SUBJECT: NuScale Power, LLC Response to NRC Request for Additional Information No. 136 (eRAI No. 8933) on the NuScale Design Certification Application

eRAI No.: 8933

NRC Question No.: 03.07.02-17

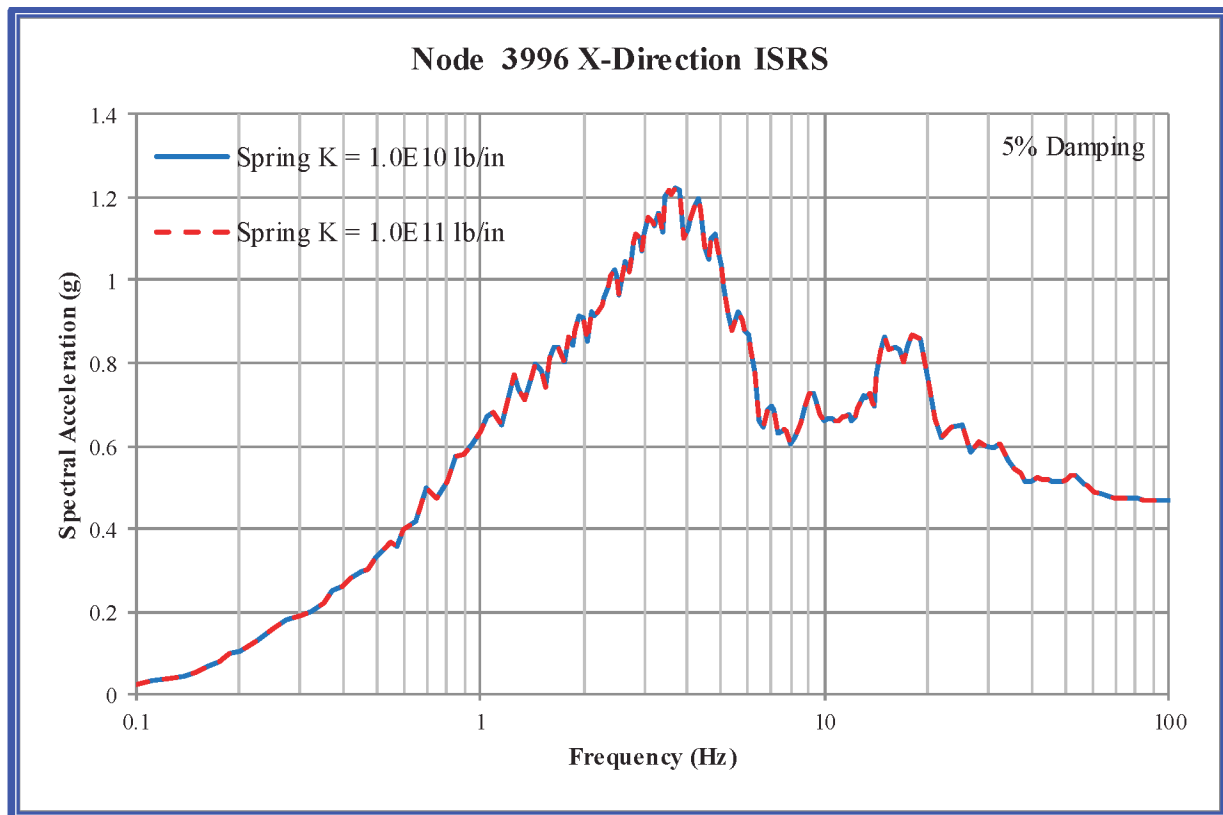
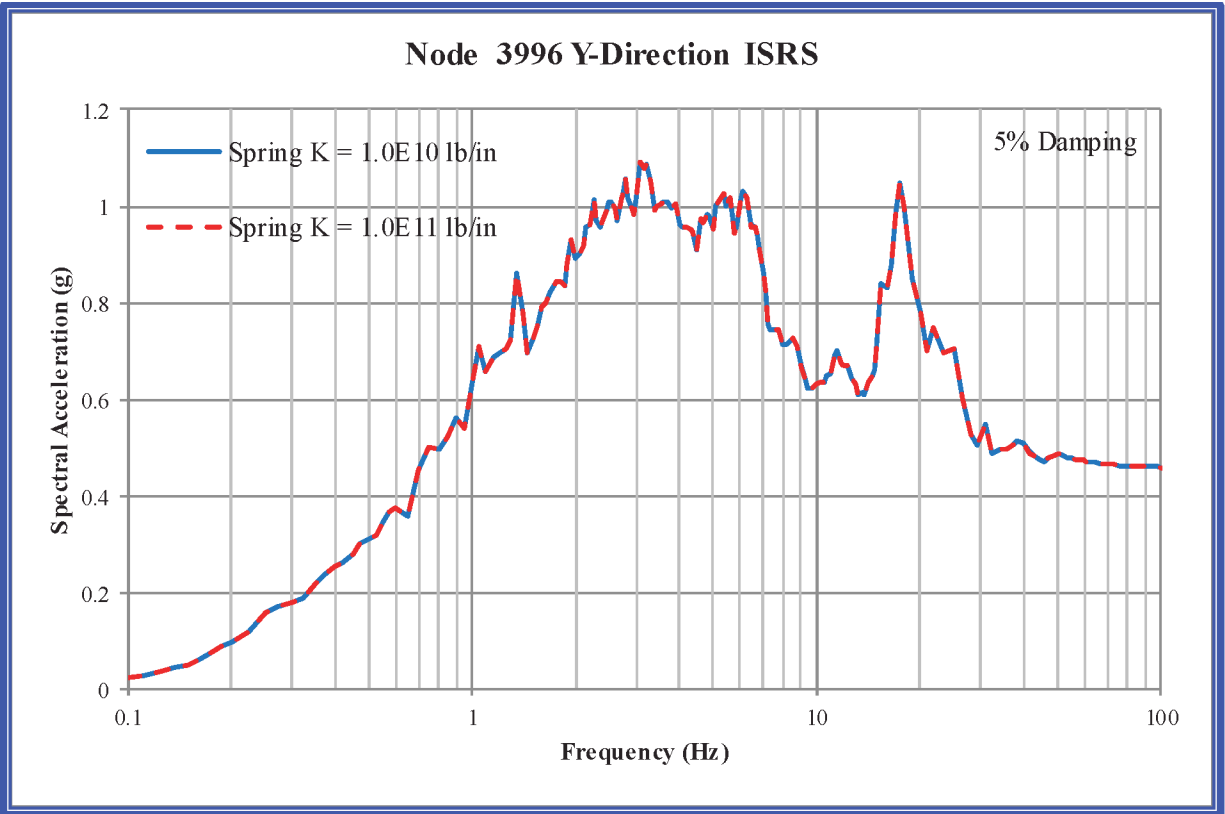
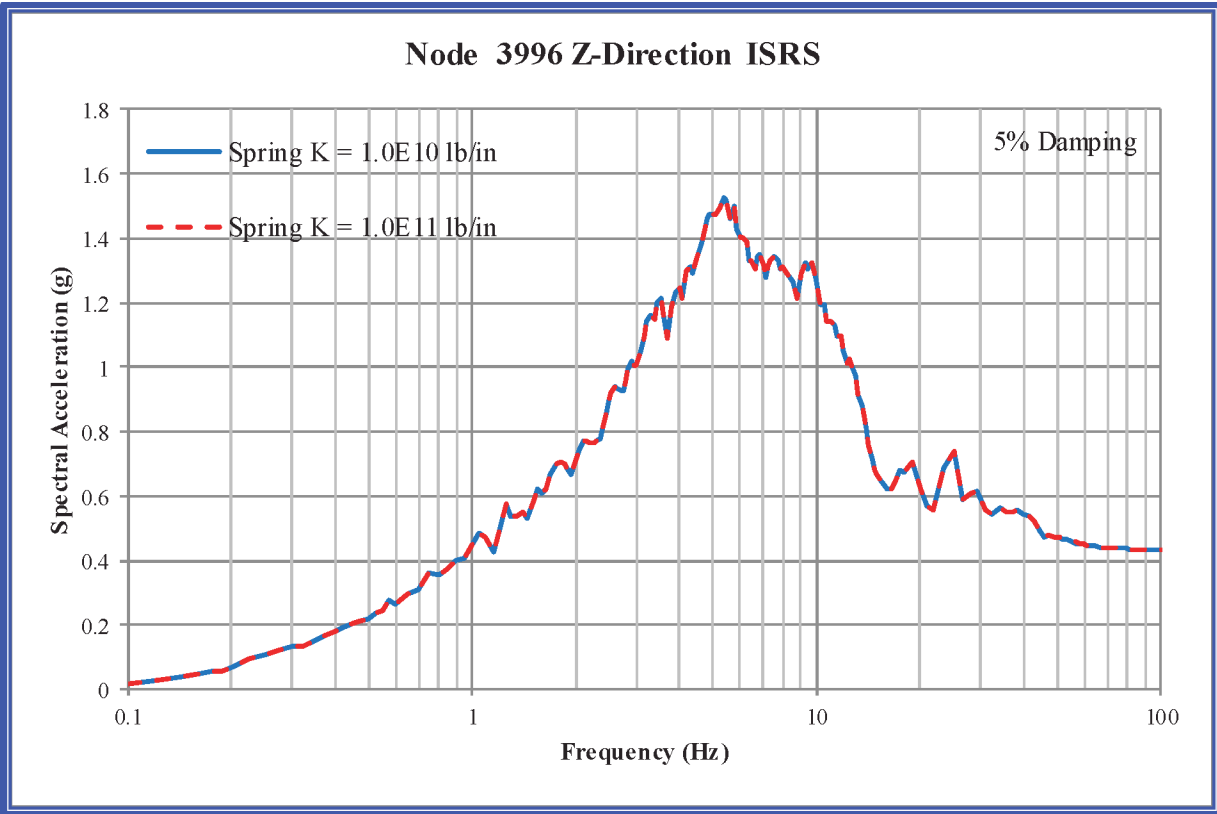
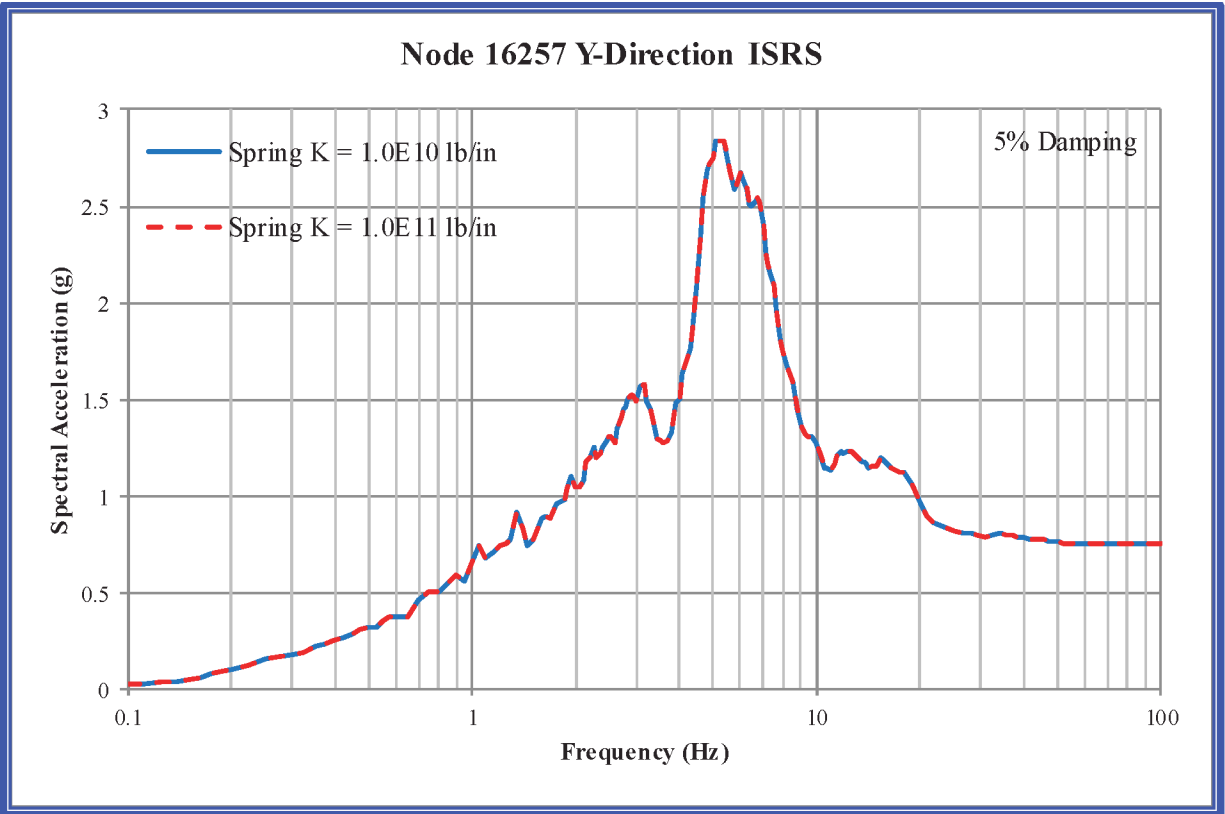
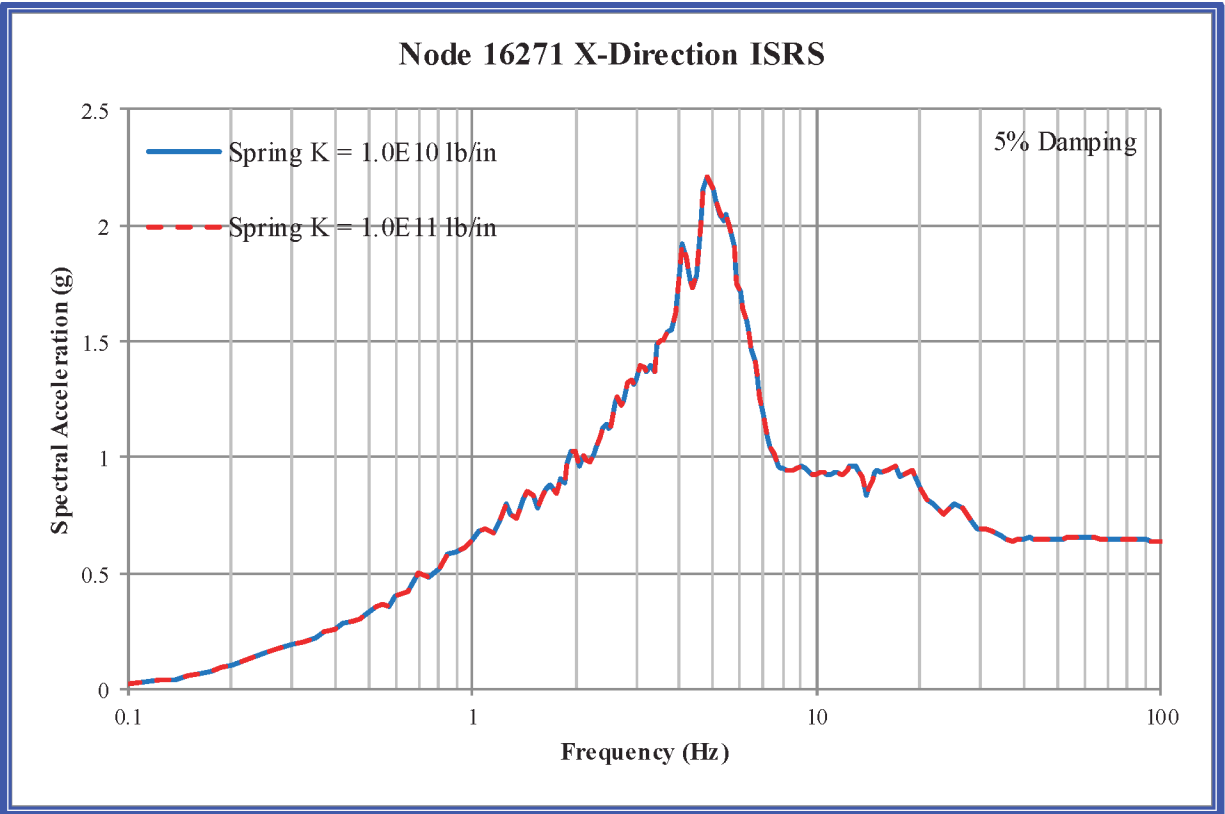
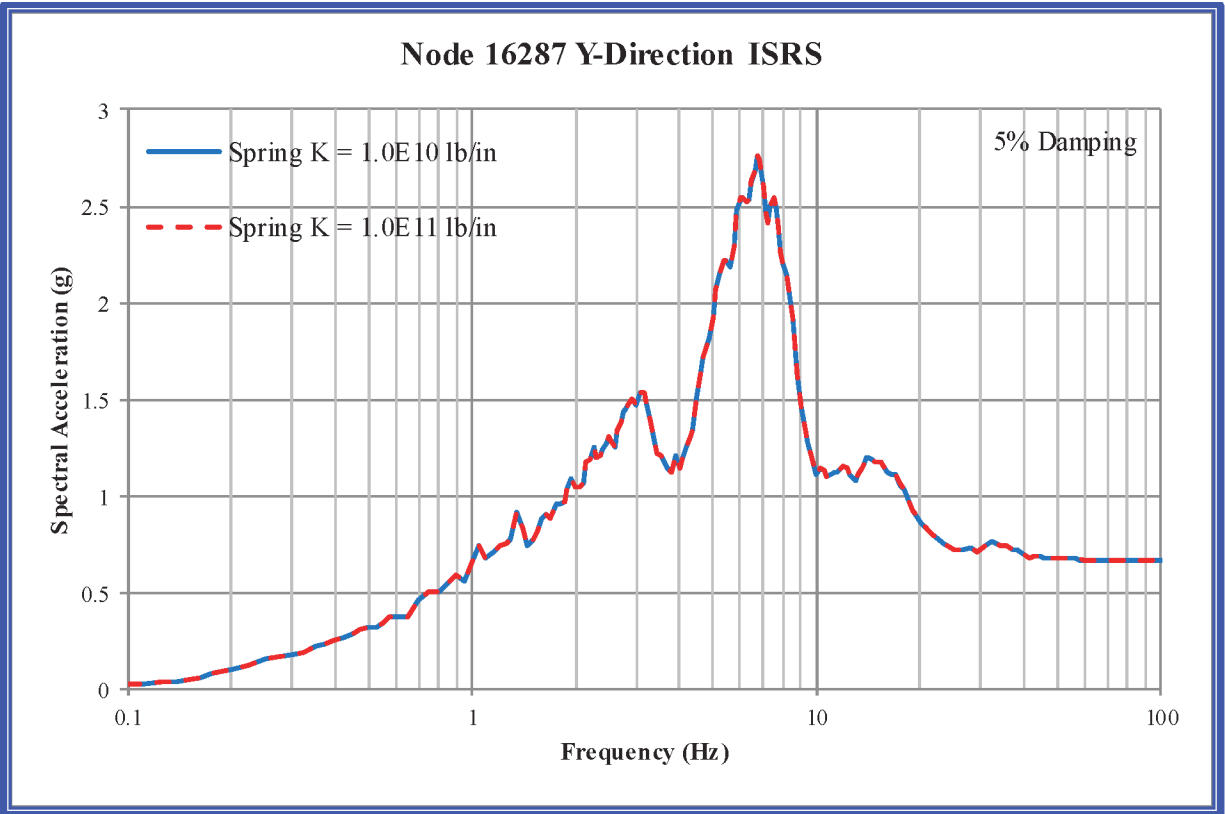
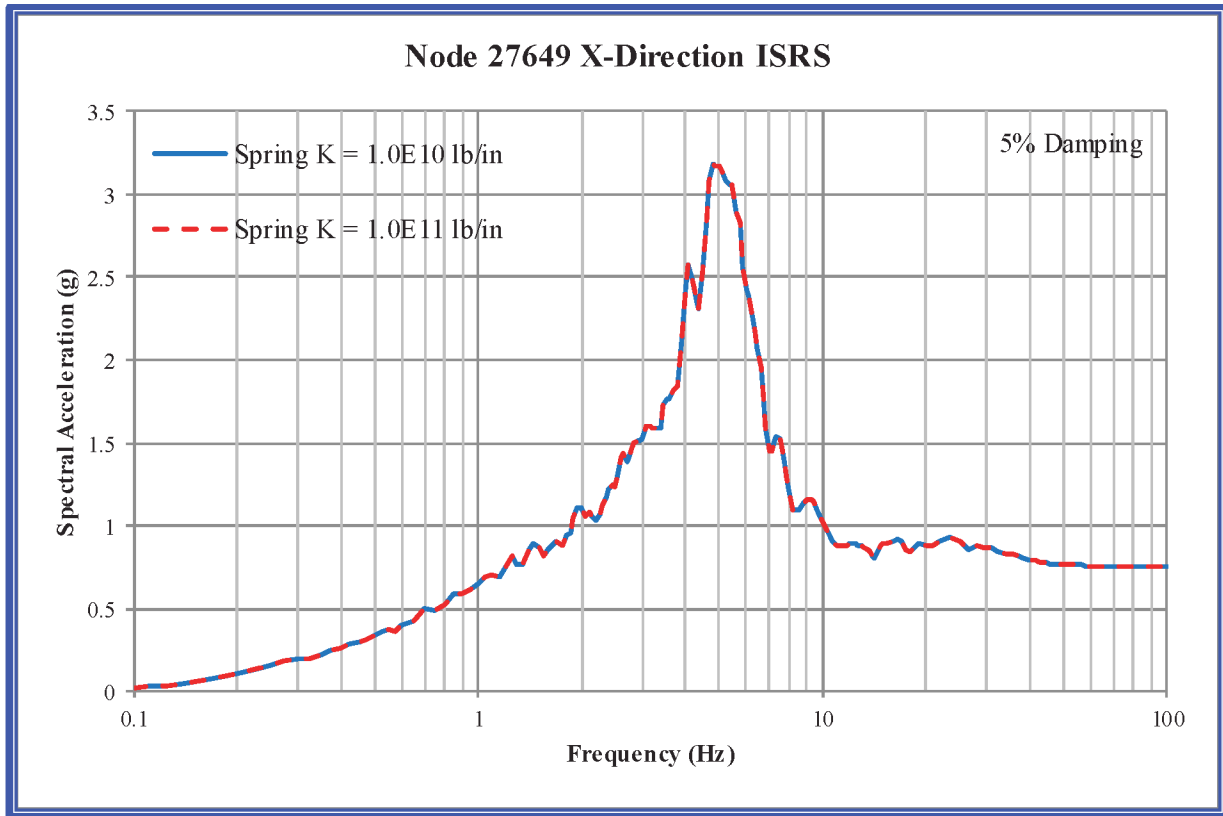
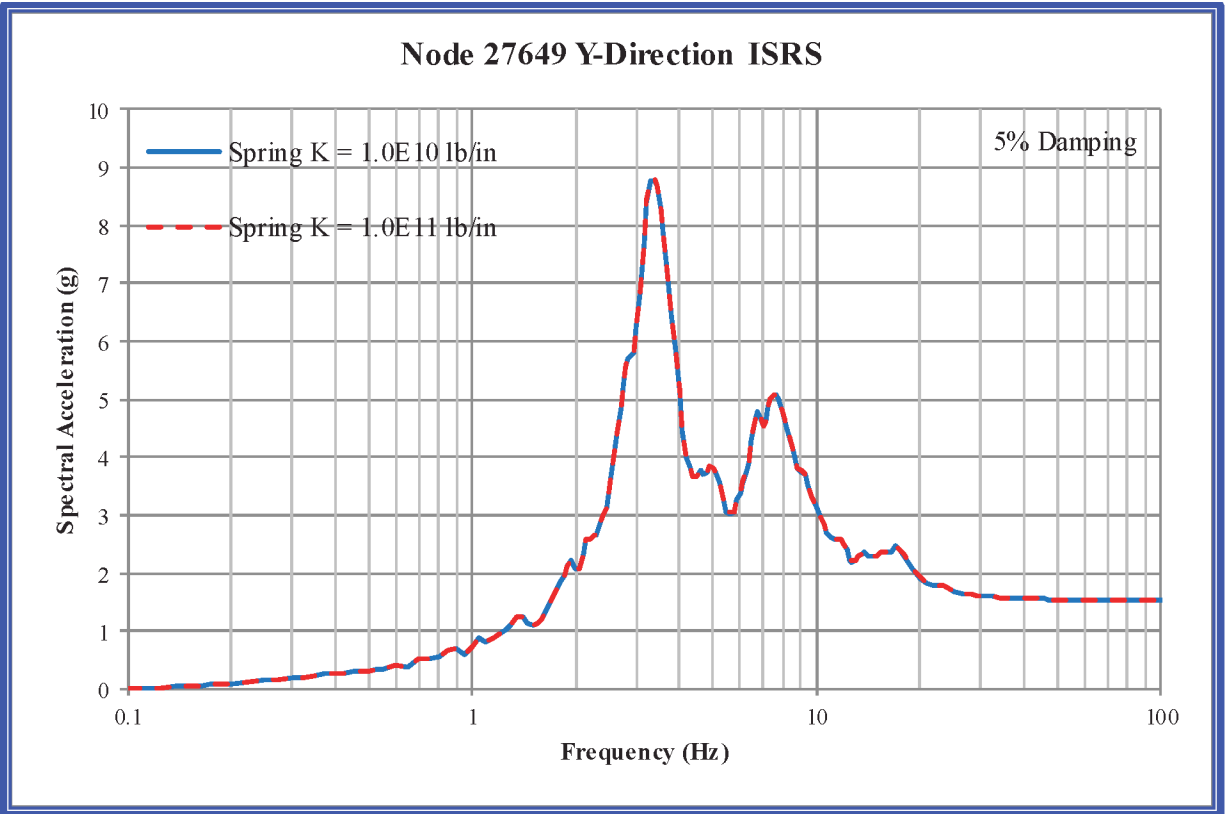
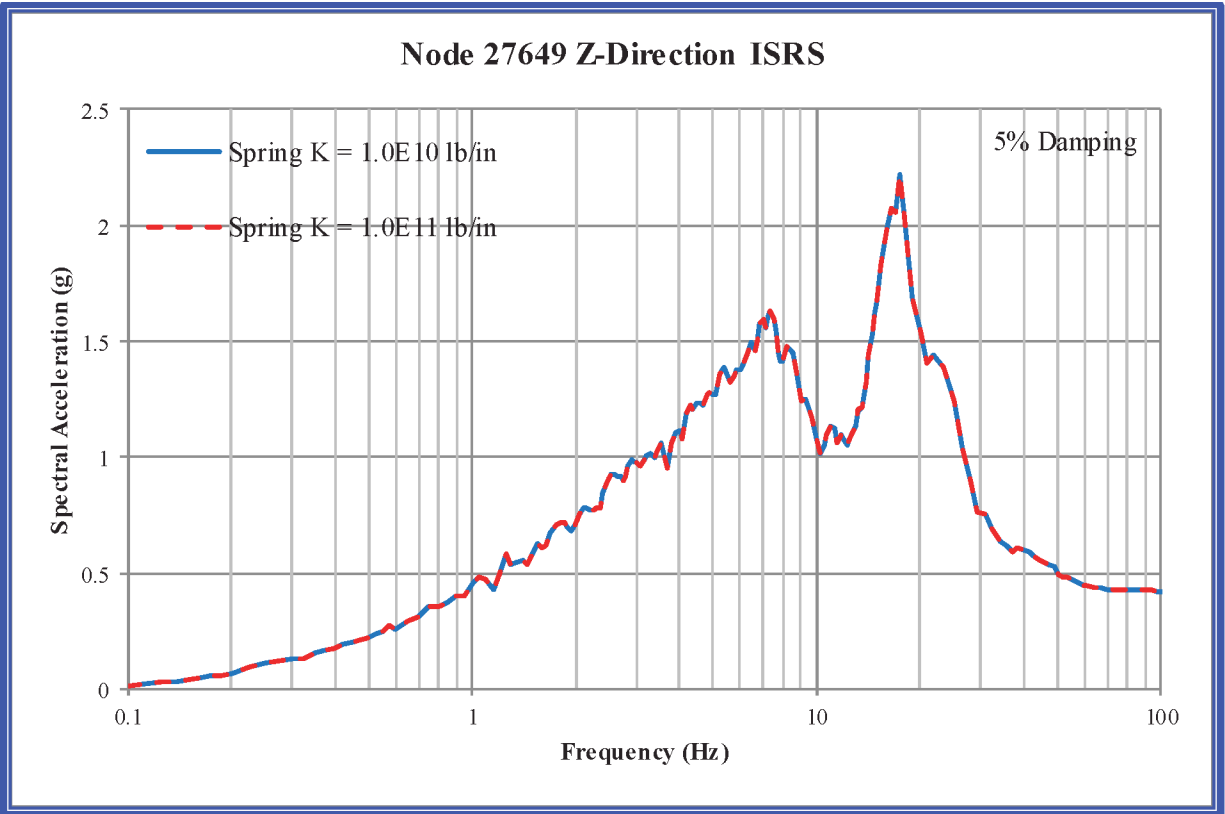
- b. On Page 3.7-25 of the FSAR, in the sixth paragraph, the applicant states, “The rigid springs have a zero length and have a stiffness value large enough to simulate rigid connection. The large stiffness used is arbitrarily chosen to be ten billion lbs per inch, or 1010 lbs/inch, in the three global directions.” For the spring to be modeled as a rigid spring, the value of its spring constant should be sufficiently larger than the stiffness of the structural element (basemat) to which it is attached. The applicant is requested to confirm the adequacy of the number (1010 lbs/inch) chosen for the spring constant by comparing it to the stiffness of the adjacent basemat element or through an appropriate sensitivity run using a number at least an order of magnitude different.

The ISRS comparisons are shown in Figure 1-20 through Figure 1-34. There are no discernible differences in the ISRS generated with spring $K = 10^{10}$ lb/in and spring $K = 10^{11}$ lb/in.
